Executive Director's Recommendation

Commission Meeting: October 4, 2018

PROJECT National World War I Memorial Pershing Park Washington, DC	NCPC FILE NUMBER 7682
SUBMITTED BY United States Department of the Interior National Park Service	NCPC MAP FILE NUMBER 1.23(73.10)44812
REVIEW AUTHORITY Commemorative Works per 40 U.S.C. § 8905 and Public Law 113-291	APPLICANT'S REQUEST Approval of comments on revised concept plans
	PROPOSED ACTION Approve comments on revised concept plans
	ACTION ITEM TYPE Staff Presentation

Comments on Concept Design

Freestanding Wall - Plan

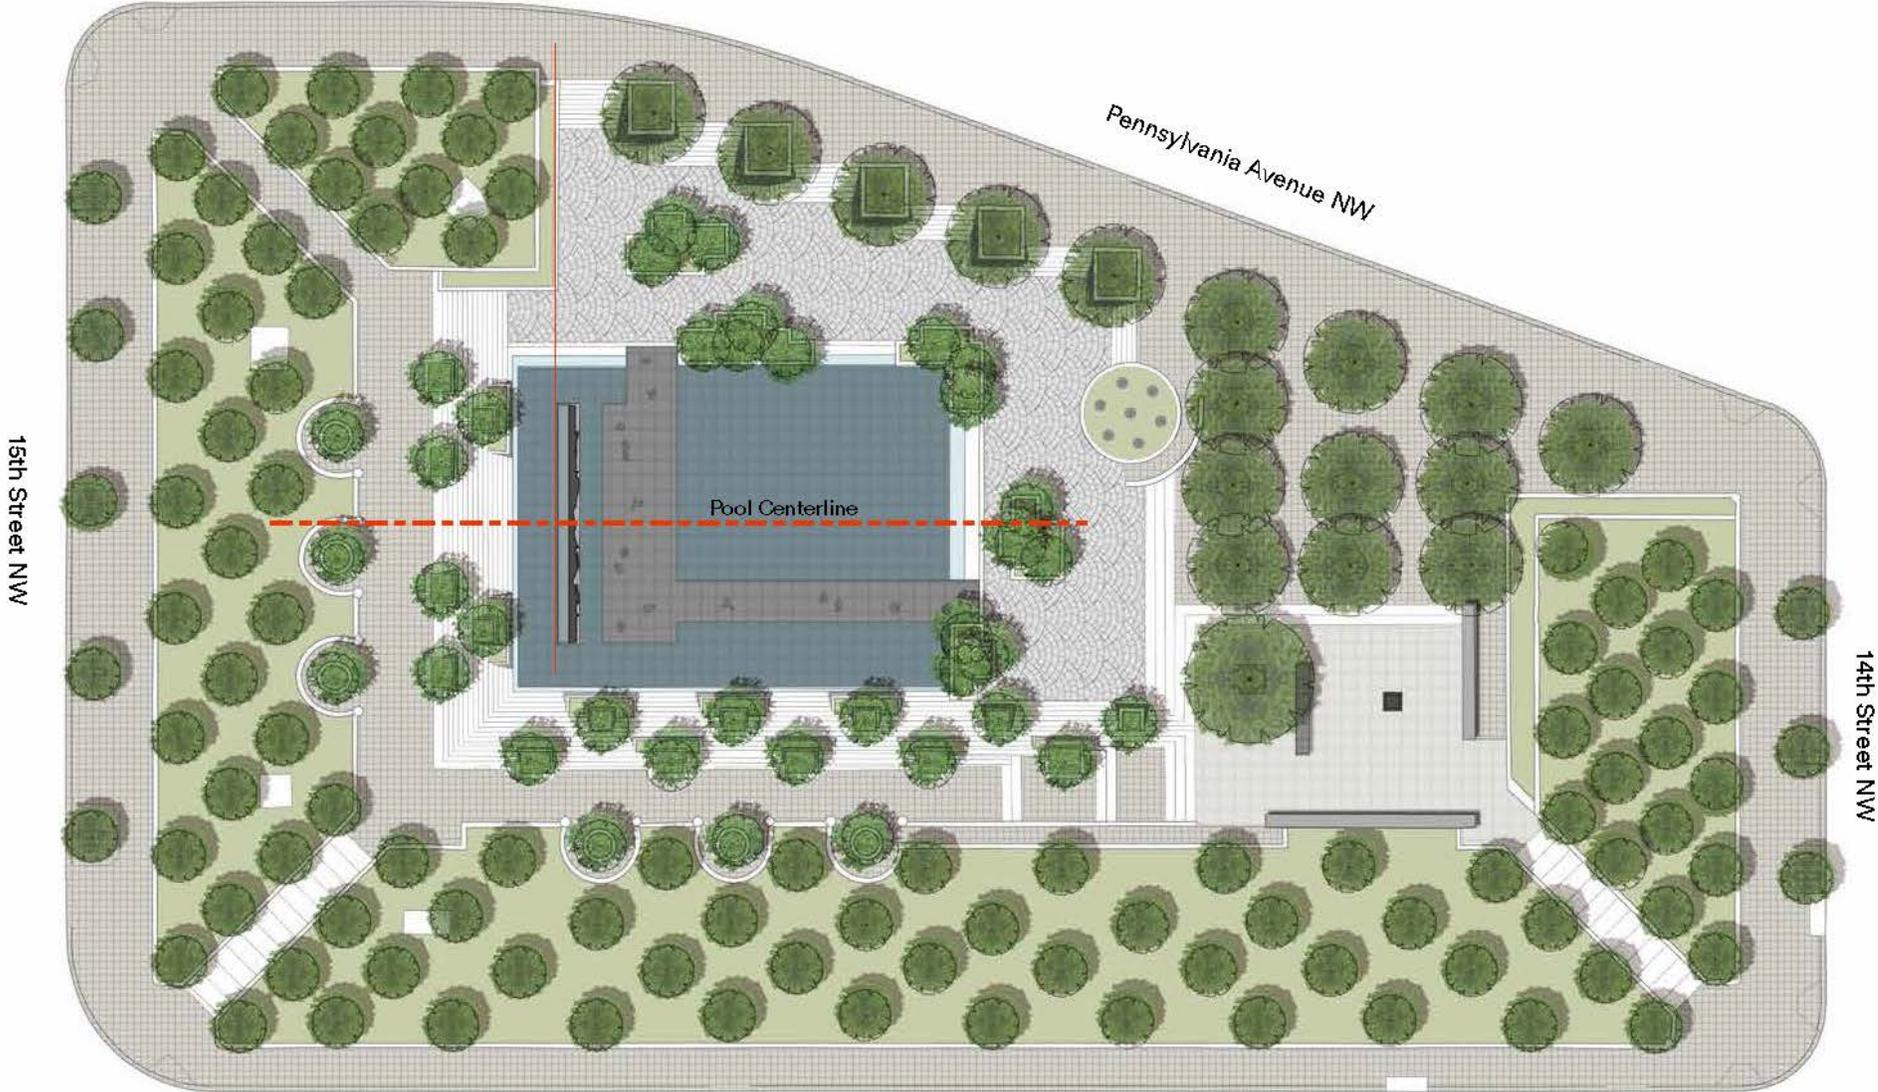
Finds the freestanding wall in its current design creates a clear front and back, and the space at the rear of the wall is not yet fully developed.

Requests the applicant provide alternative design strategies that treat the memorial element in a unified way, without a front or a back, so that it is not perceived as dividing the park, but a feature that can engage visitors from all sides. Alternative strategies should also consider the treatment of the western steps and how the space might be designed to encourage people to gather and use the space in a positive way.

West Side of Freestanding Wall

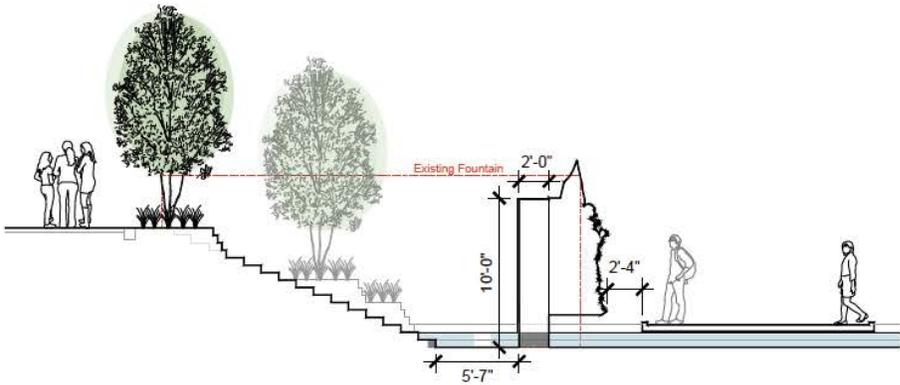
By moving the memorial wall into the pool, it becomes a feature with multiple sides and multiple viewpoints. The eastern face and sculpture is intended to be the primary view, however the standalone wall creates a secondary face that will be visible and must be treated appropriately. The applicant has proposed a waterfall and inscriptions on the western side, but it is unclear if this will be sufficient to create a space that will attract visitors or be comfortable to occupy.

Likewise, the space created by the wall and western steps should be a space that is comfortable and engaging to visitors. It is unclear whether the current design will accomplish this. As such, staff recommends the **Commission find the freestanding wall in its current design creates a clear front and back, and the space at the rear of the wall is not yet fully developed.** For example, it is uncertain whether the freestanding element is sufficiently set back from the terrace steps, or whether additional space is necessary to create an appropriate viewpoint for the freestanding element. Further, the applicant should evaluate how the western steps will be used given the new design. While extending the Friedberg designed steps may be appropriate, alternatives should be developed to explore additional seating, plantings or other approaches that respond to the new freestanding wall and allow the space to be useful and inviting. As such, staff recommends the **Commission request the applicant provide alternative design strategies that treat the memorial element in a unified way, without a front or a back, so that it is not perceived as dividing the park, but a feature that can engage visitors from all sides. Alternative strategies should also consider the treatment of the western steps and how the space might be designed to encourage people to gather and use the space in a positive way.**

Walkway Options

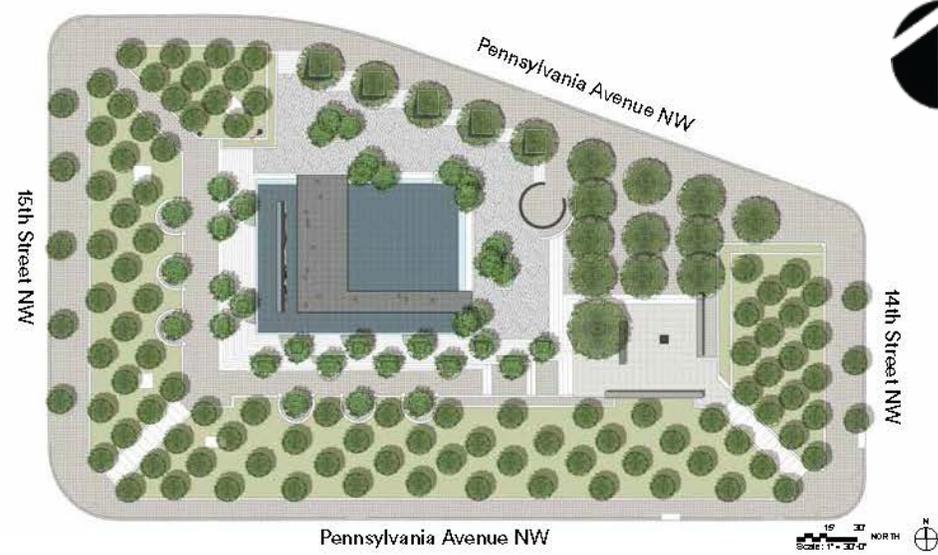
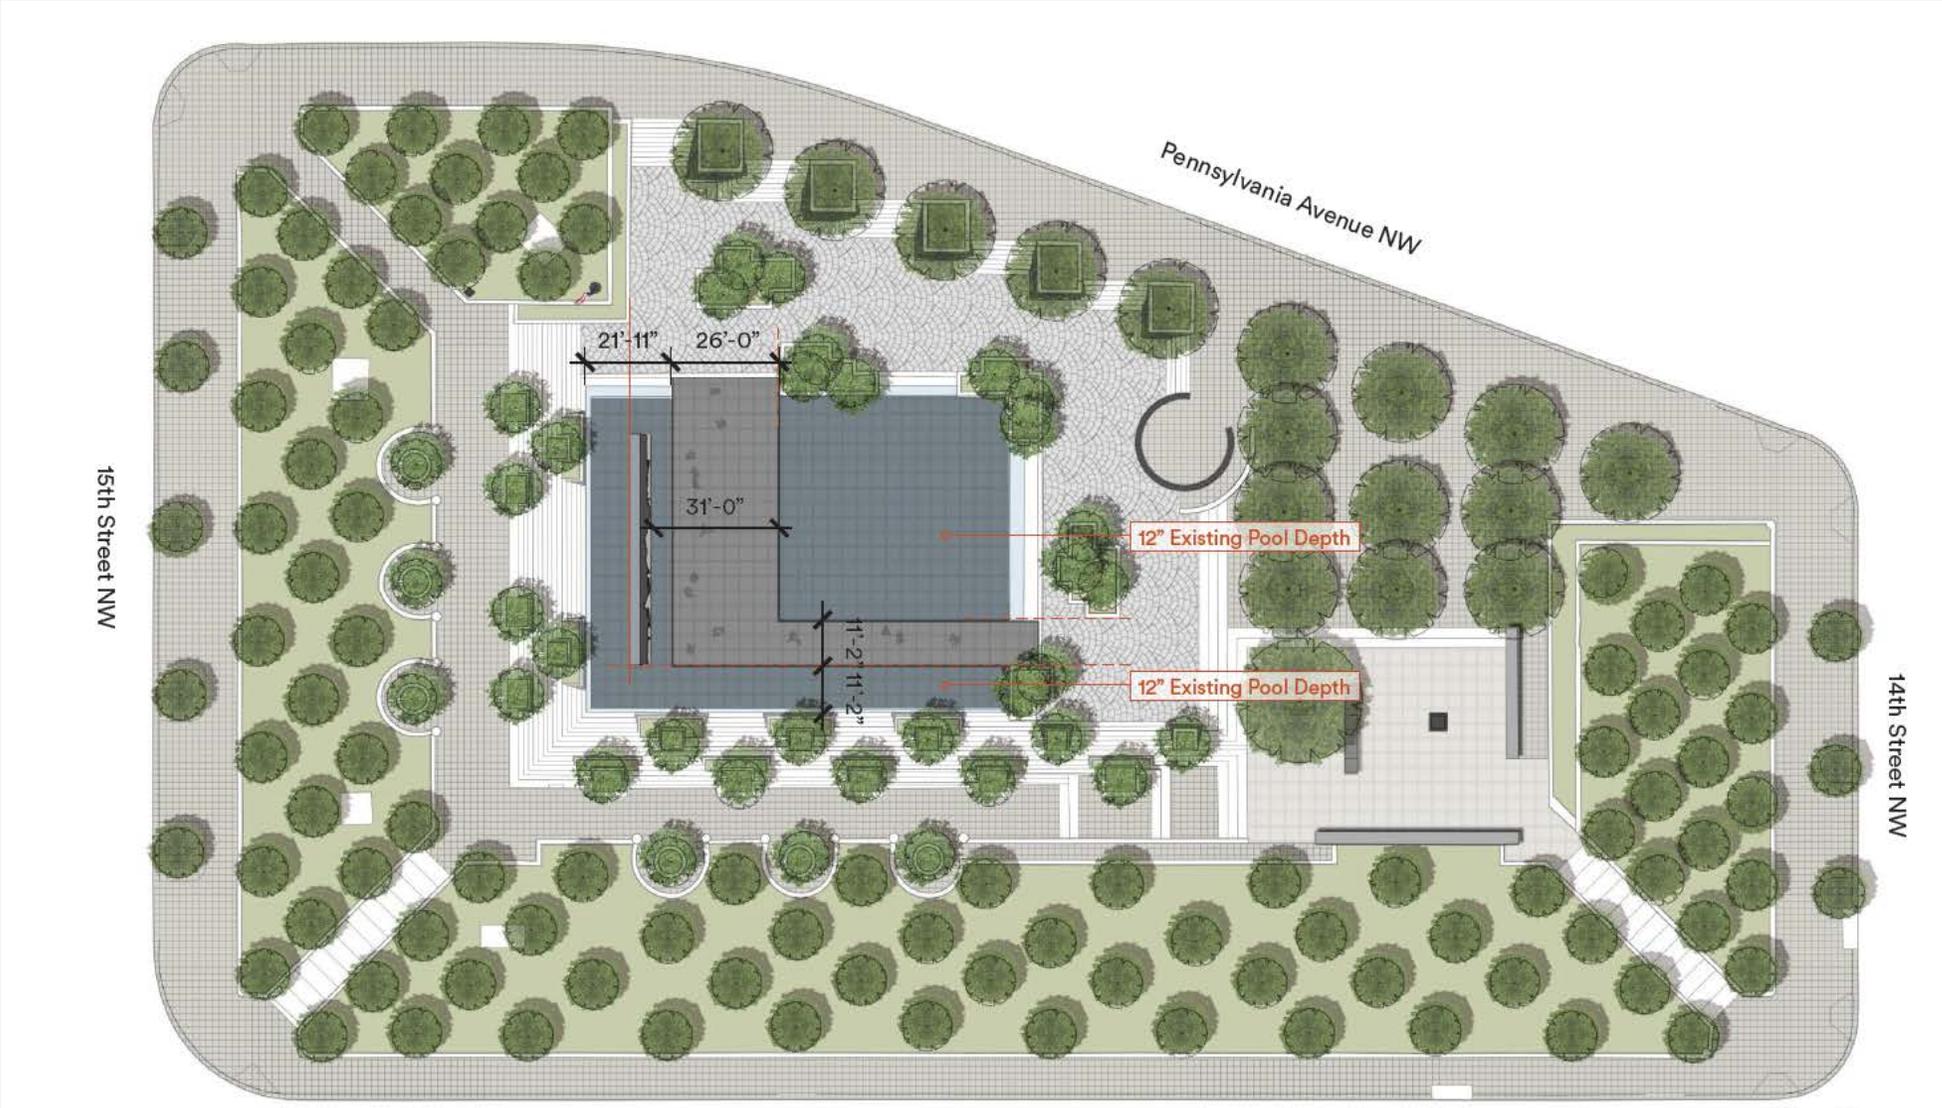
Notes the applicant has developed three options for the pool and walkway configuration.

Requests that for each of the three options, the applicant describe how the water feature and plaza area will be used throughout the year, recognizing the extreme temperatures of the summer and winter months.

“L” Walkway – 12” pool depth

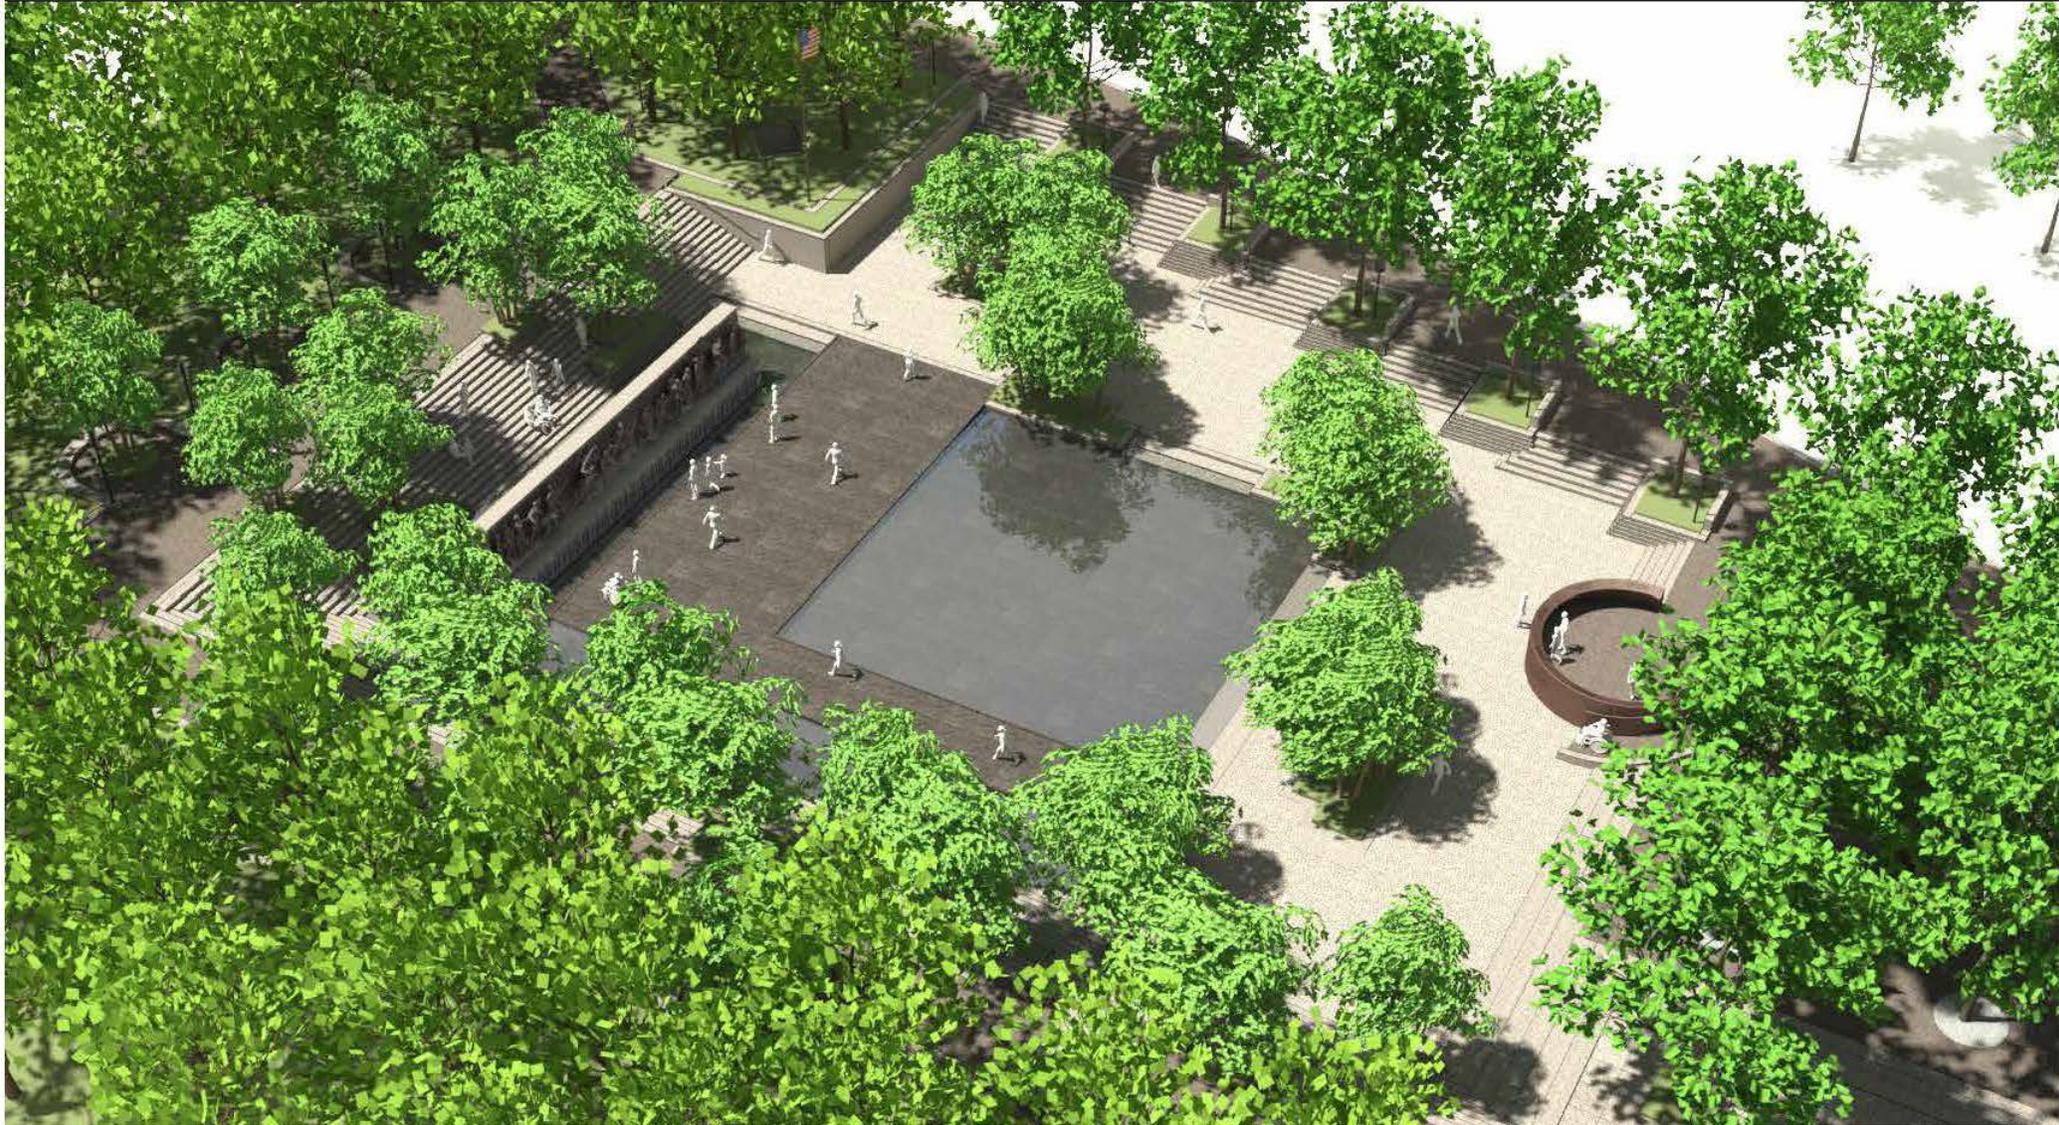
Finds the "L" Walkway with Existing Pool Depth most closely retains the original pool depth and configuration, and provides a new pedestrian connection between the eastern and northern portions of the plaza.
